Three lines of thought about Lower Shaker Lake dam

- 1) Downsizing the NEORSD design would meet local needs
- 2) Understanding the dam failure hazards and working towards a non-Class-I project**
- 3) The lake and the 15 minute city

Ben Monreal
Shaker Heights
Professor of Physics, CWRU

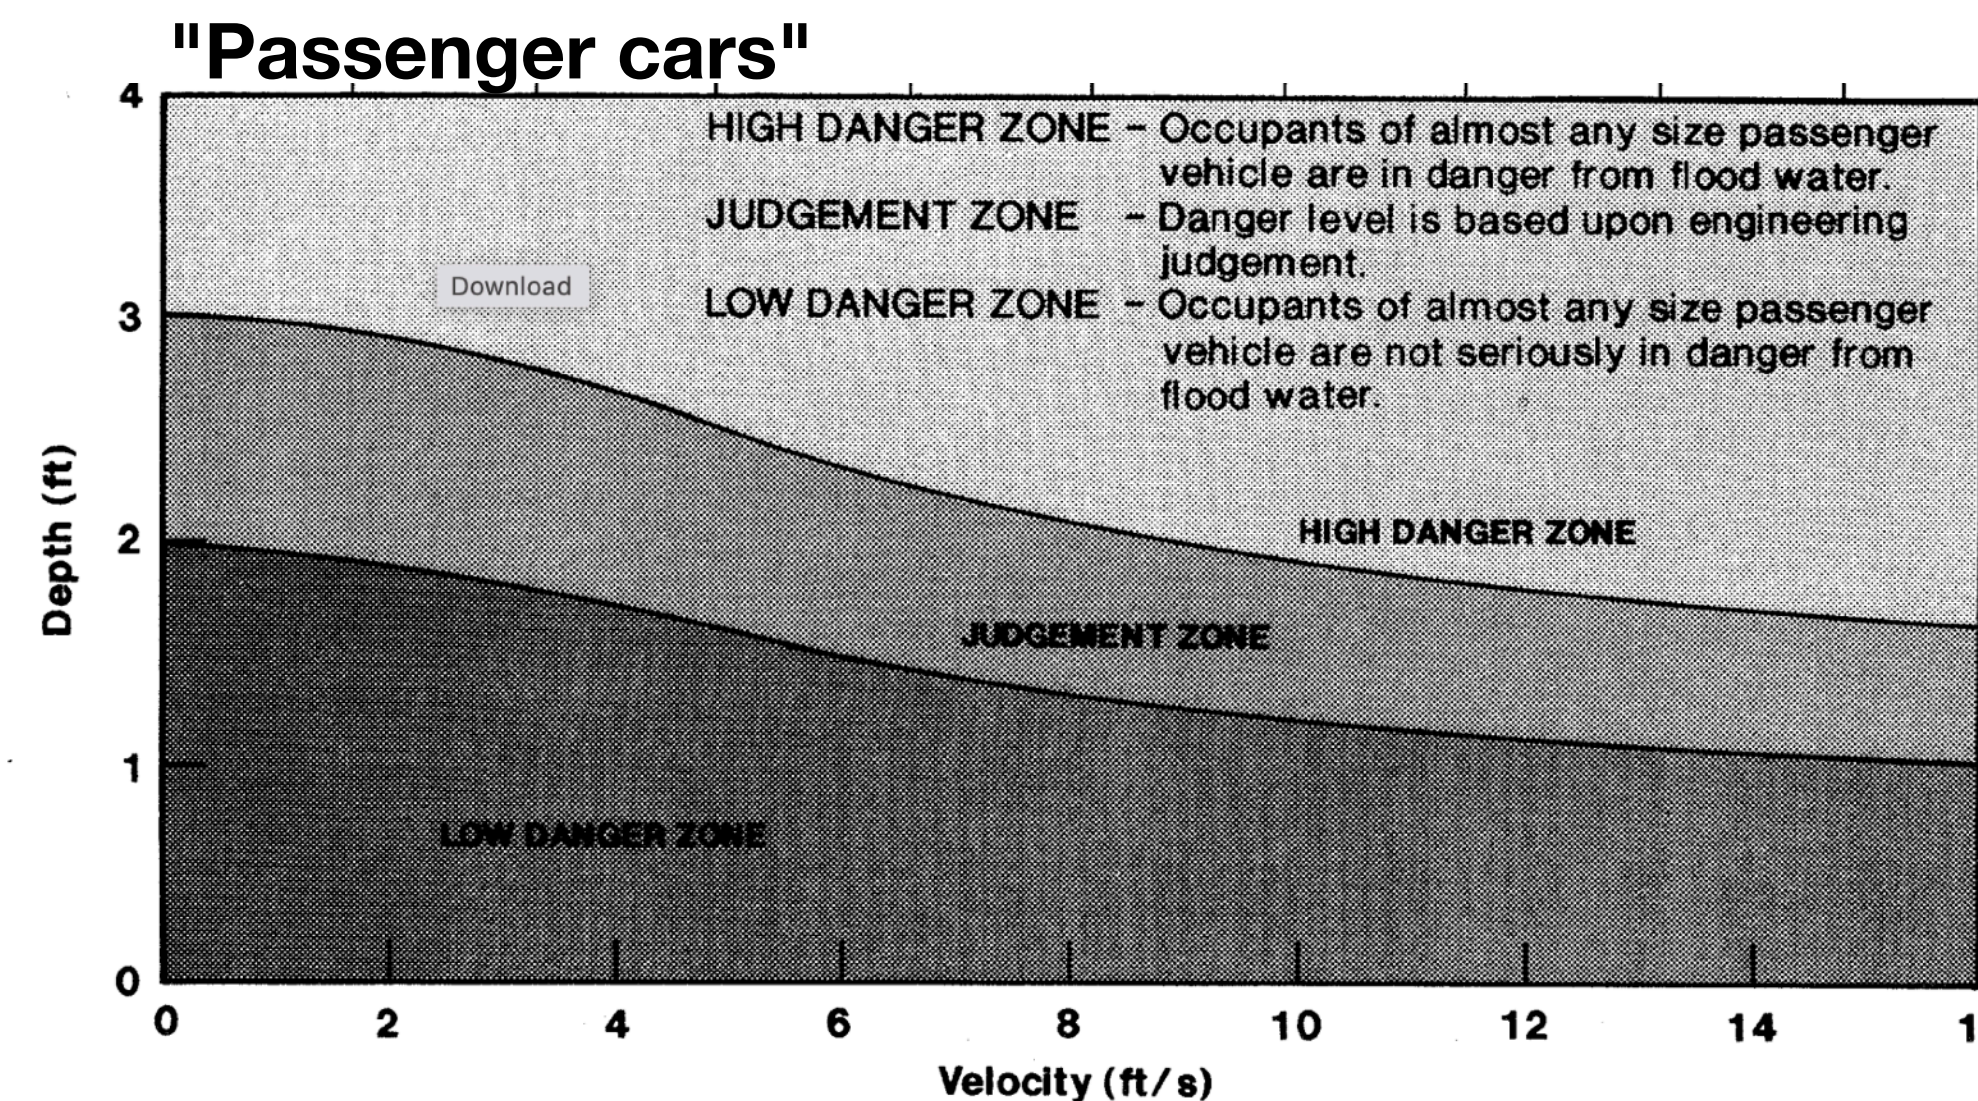
6 feet of still water is not "high danger"!!

< 3 feet of still water and <2 feet of fast water is still not "high danger" on this chart. I don't

Figure 6. - Depth-velocity flood danger level relationship for children.

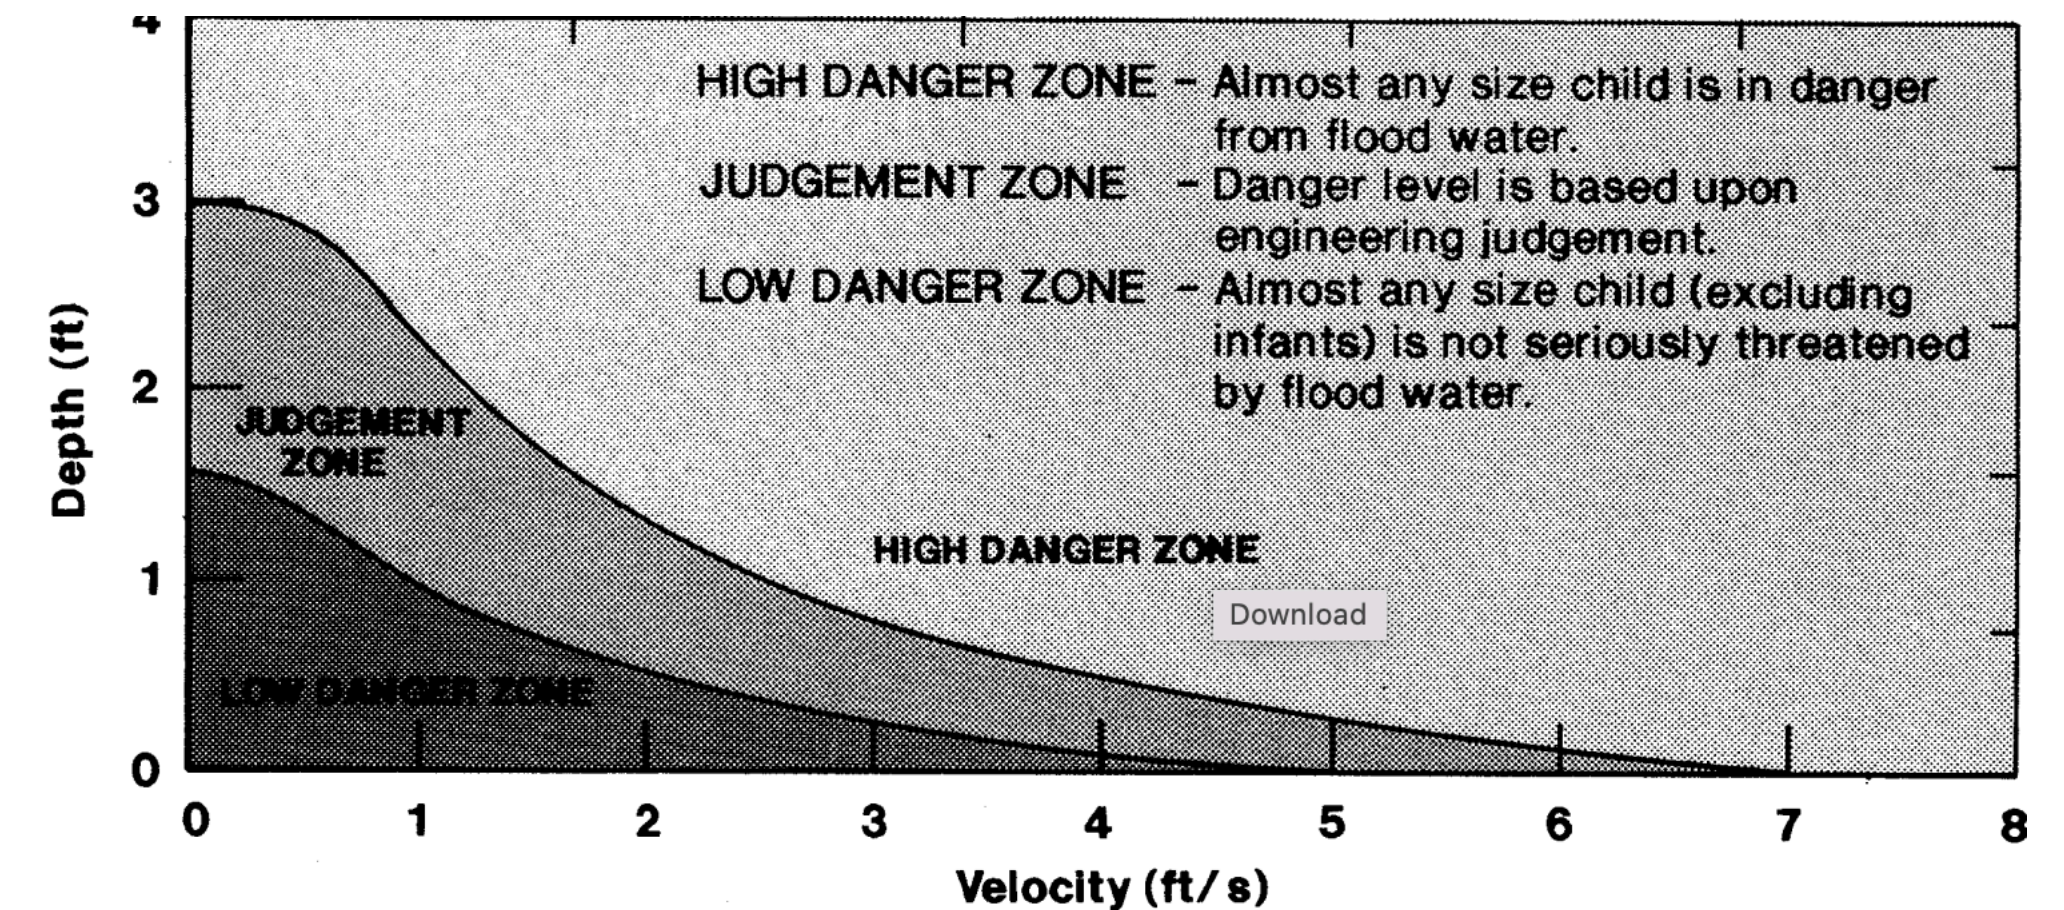
Could any sidewalk in the floodplain flood this deep? (High danger zone only, as with cars)

- Near the lake: *if* it's possible now I am pretty sure the NEORSD second culvert totally prevents it
- University Circle: not sure

USBR guidelines say: If you don't have analysis that predicts depth and flow, you have to assume high hazard anywhere there is water (!)

Doan Canyon flood capacity is relevant

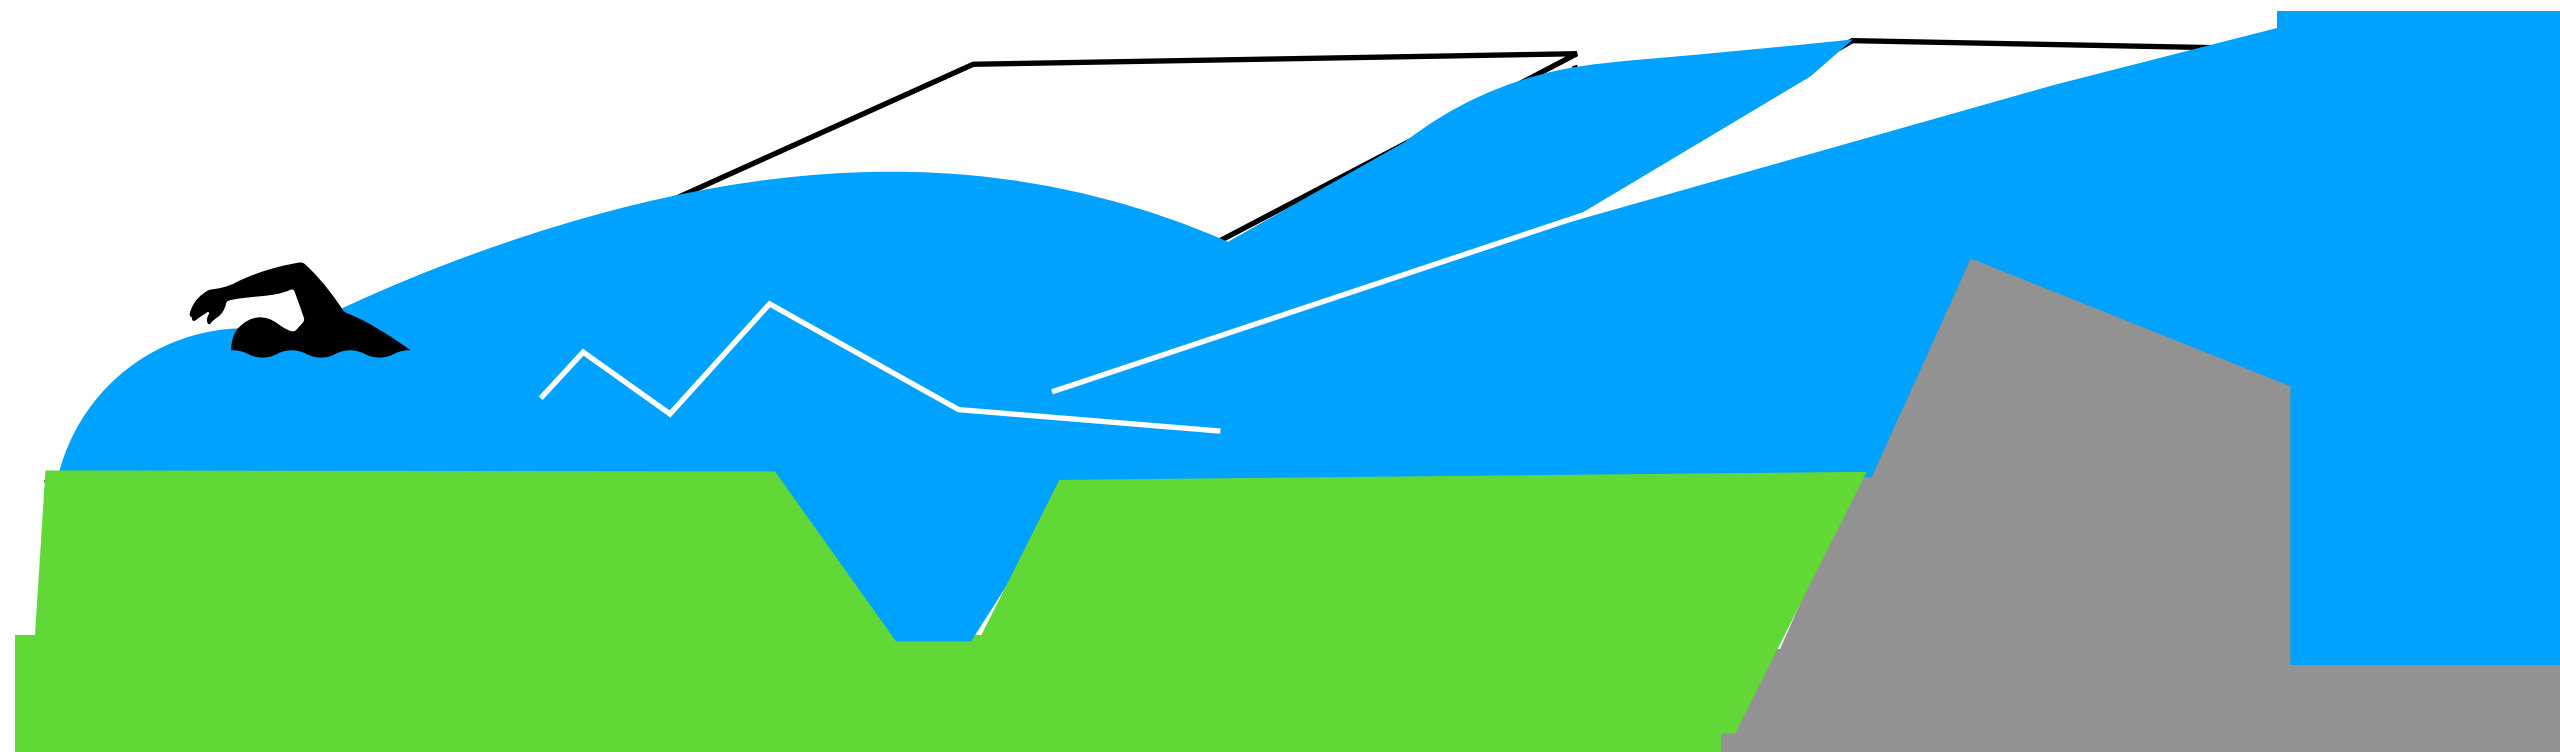
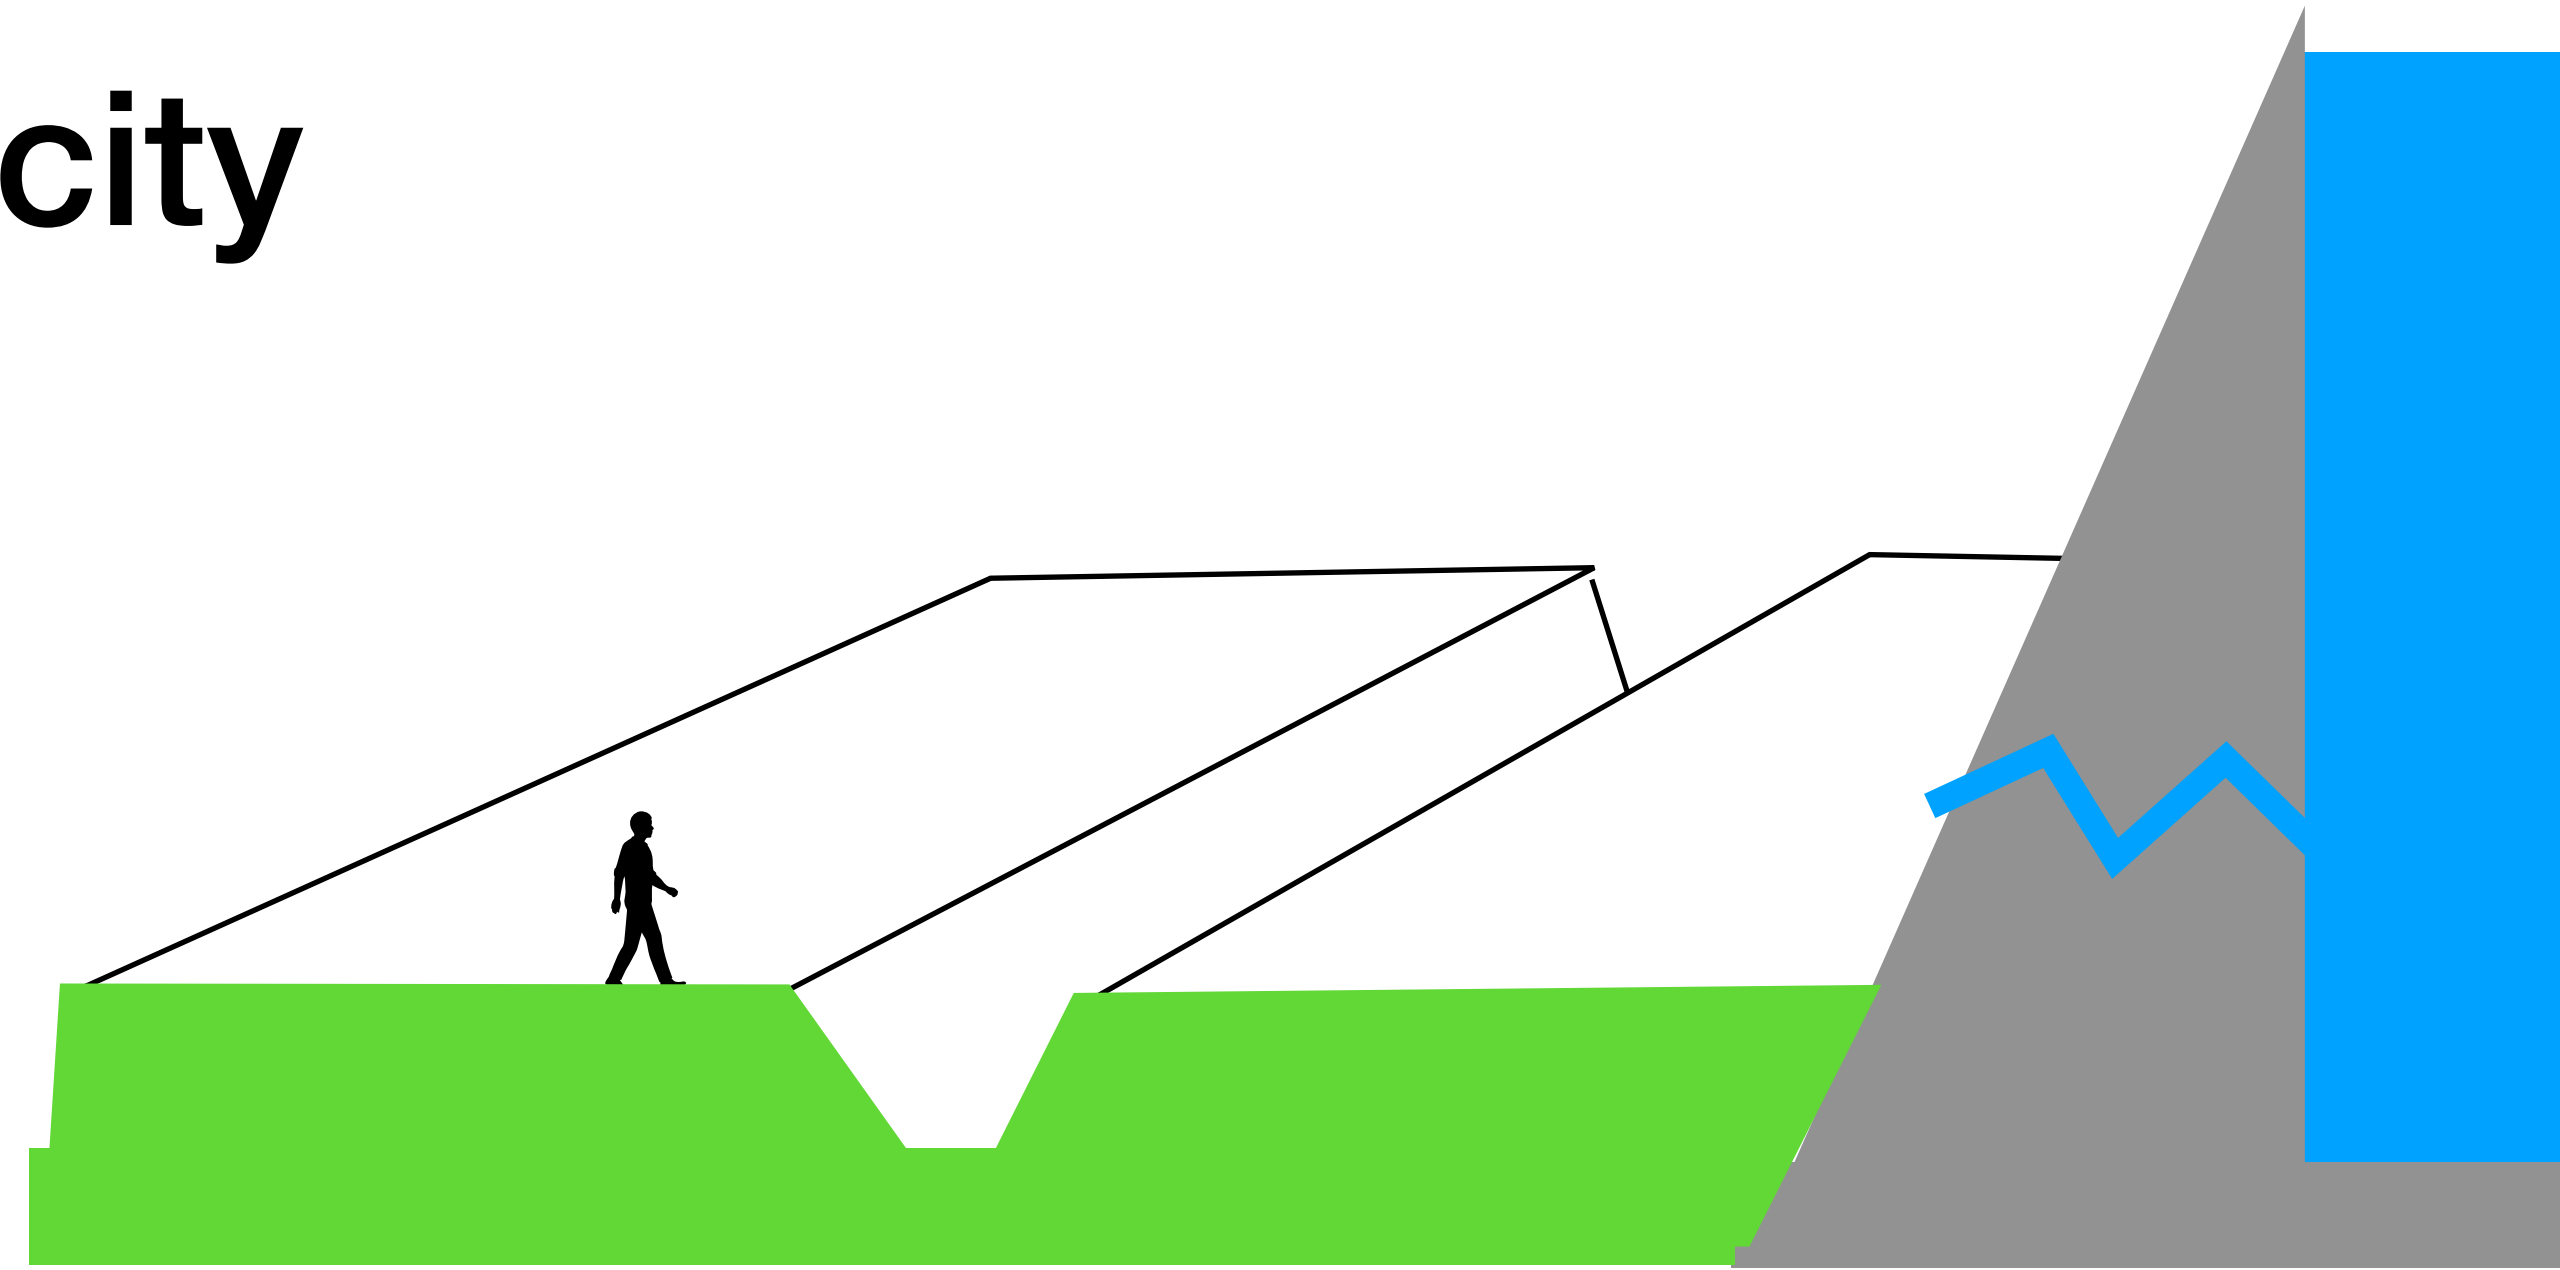
- Dumping a lot of water into a tiny channel that's not used to it = overflow = hazard
